# UNITED STATES PATENT AND TRADEMARK OFFICE

<b>Office Action Summary</b>	<b>Application No.</b> 10/736,618	<b>Applicant(s)</b> OHKURA, YOSHIHIRO 	
	<b>Examiner</b> DiLinh Nguyen	<b>Art Unit</b> 2814

**DETAILED ACTION**

Fig.1

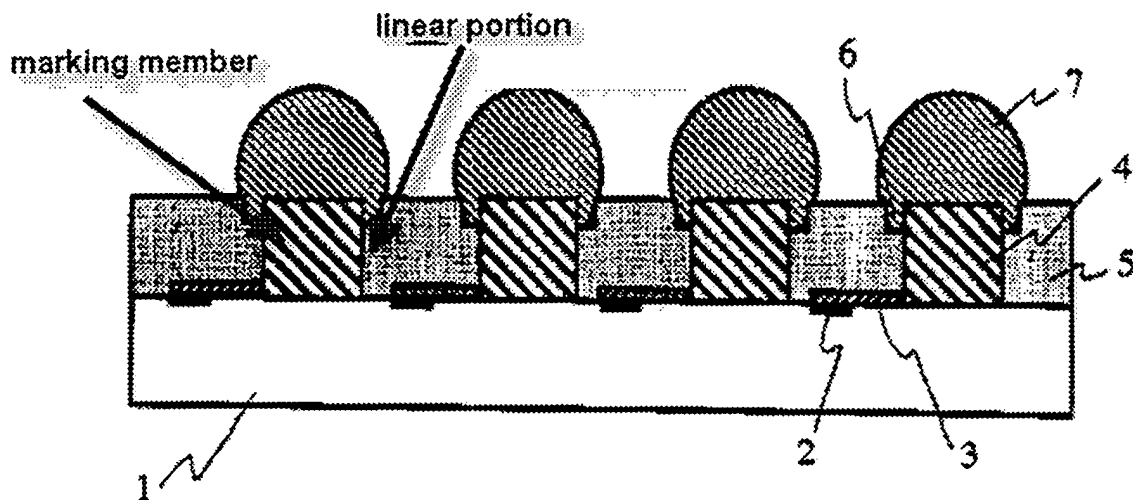
Ohuchi et al. disclose a surface mount chip package incorporating a semiconductor chip having an integrated circuit, comprising:

a package housing 5 made of a resin that covers the semiconductor chip 1 while avoiding a plurality of conductors 4 extending from the semiconductor chip 1;

a plurality of external electrodes 7 that are arranged in the package housing 5 in correspondence with a main surface of the semiconductor chip having the integrated circuit and are connected with the plurality of conductors extending from the semiconductor chip; the external electrodes 7 each having a circular shape when viewed in a thickness direction of the semiconductor chip; and

at least one marking member that is arranged in the package housing so as to realize a directivity when viewed in the thickness direction of the semiconductor chip,

wherein an outline shape of the marking member includes at least one linear portion (fig. 1, column 2, lines 56 et seq.).

- Regarding claim 3, Ohuchi et al. disclose that the marking member corresponds to a copper post (fig. 1, column 3, line 1) but do not explicitly disclose the marking member is arranged independently of the plurality of conductors. However, AAPA discloses that the marking member 520 is arranged independently of the plurality of conductors (fig. 6). Therefore, it would have been obvious to one having ordinary skill in the art to modify the device of Ohuchi et al. by having the marking member is arranged independently of the plurality of conductors, as taught by AAPA (fig. 6), in order to provide an index solder ball for use for the chip direction (page 2, lines 21-22).

- Regarding claim 4, Ohuchi et al. disclose that the copper post serving as the marking member has a square shape (fig. 1).
- Regarding claim 5, Ohuchi et al. disclose that the copper post is covered with a solder layer 7 (fig. 1, column 3, line 35).

- Regarding claim 6, Ohuchi et al. disclose that the marking member has a square shape (fig. 1).
- Regarding claims 7-9, Ohuchi et al. disclose that the marking member corresponds to a copper post (column 3, line 1) and it would have been obvious to increase in size compared with each of the plurality of conductors 4 (fig. 1).

Applicant's arguments have been fully considered but they are not persuasive because Ohuchi et al. clearly disclose the package comprising the external electrodes 7 each having a circular shape when viewed in thickness direction of the semiconductor chip and wherein an outline shape of the marking member includes at least one linear portion (fig. 1, column 2, lines 56 et seq.).
